Date: August 17, 2022

Re: 74-80 Maynard Road, Sudbury, MA (Assessors map G08 Parcels 0025 and 0500),  
DEP #301-1341

LIMIT OF DISTURBANCE CHANGE  
 -BONNIE BROOK ESTATES-  
 DEFINITIVE PLAN OF LAND  
 MAYNARD ROAD  
 SUDBURY, MA

**GRADING & EROSION CONTROL  
 - BONNIE BROOK ESTATES -  
 DEFINITIVE PLAN OF LAND  
 MAYNARD ROAD  
 SUDBURY, MA**

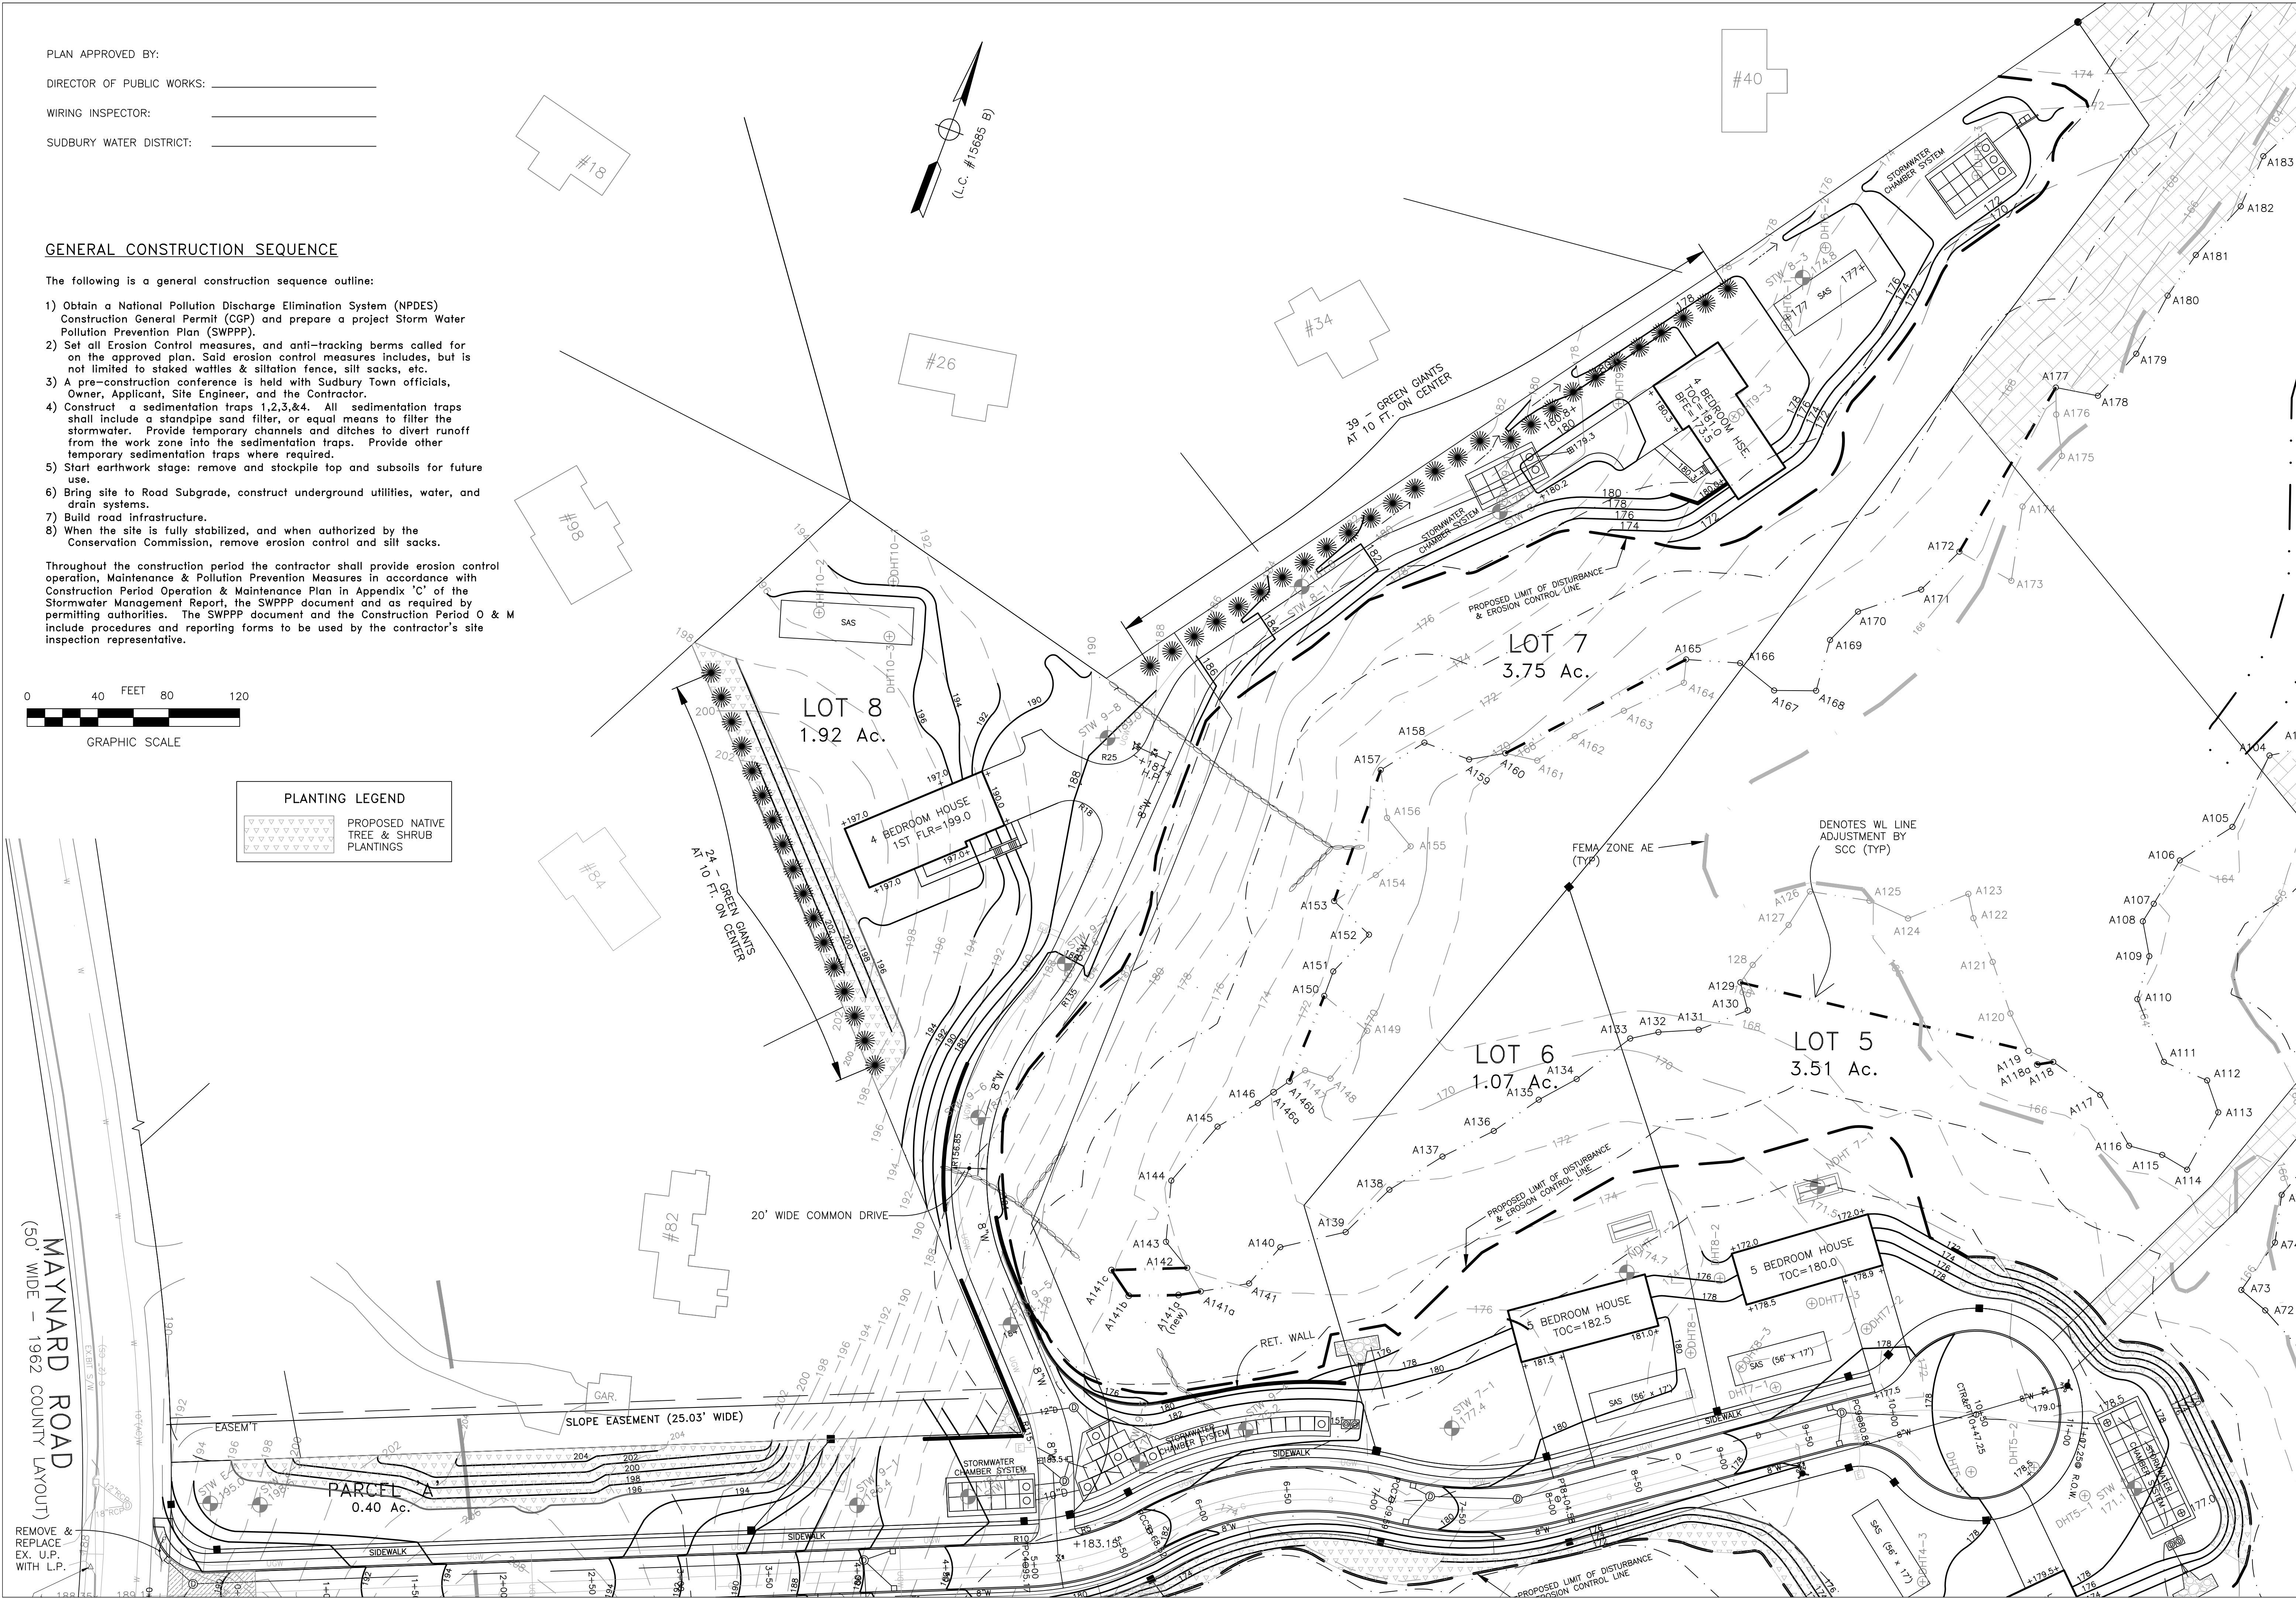
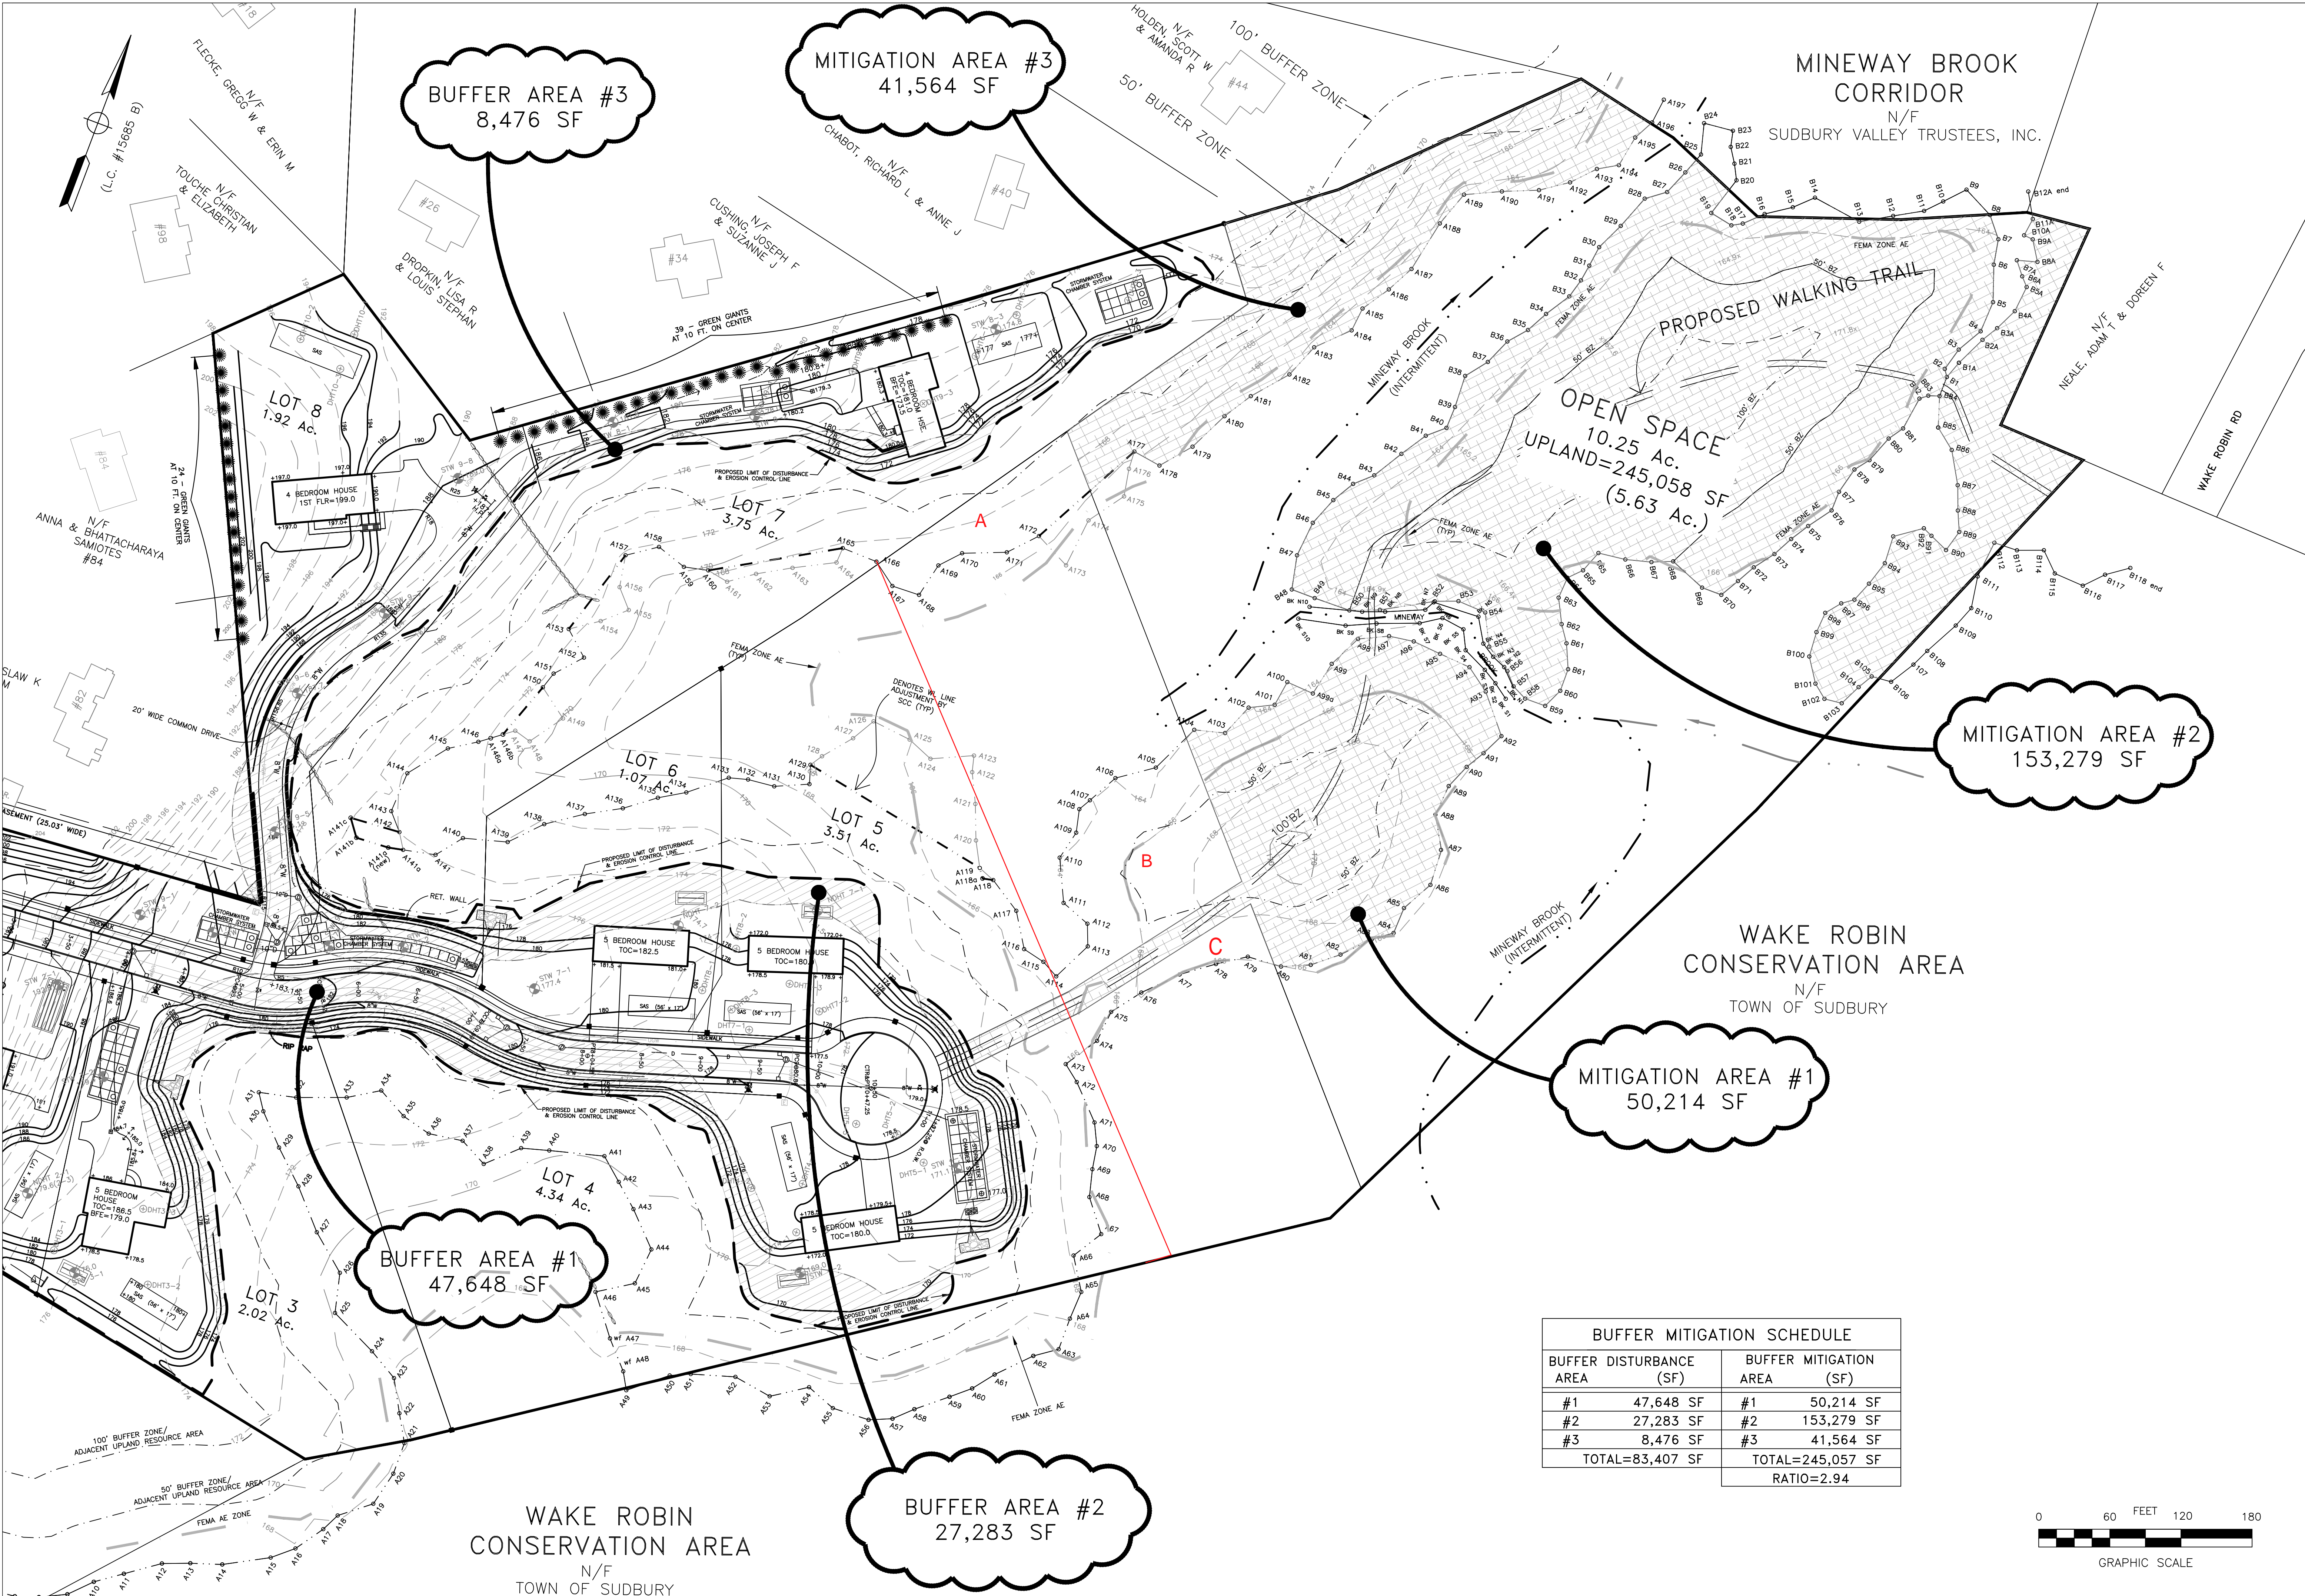
2. The current revised plan will provide upland access from the new roadway to the open space.
3. We squared out some backyard of the 6 house lots so the future home owners have a better usable yard and not to endanger the house with large trees.
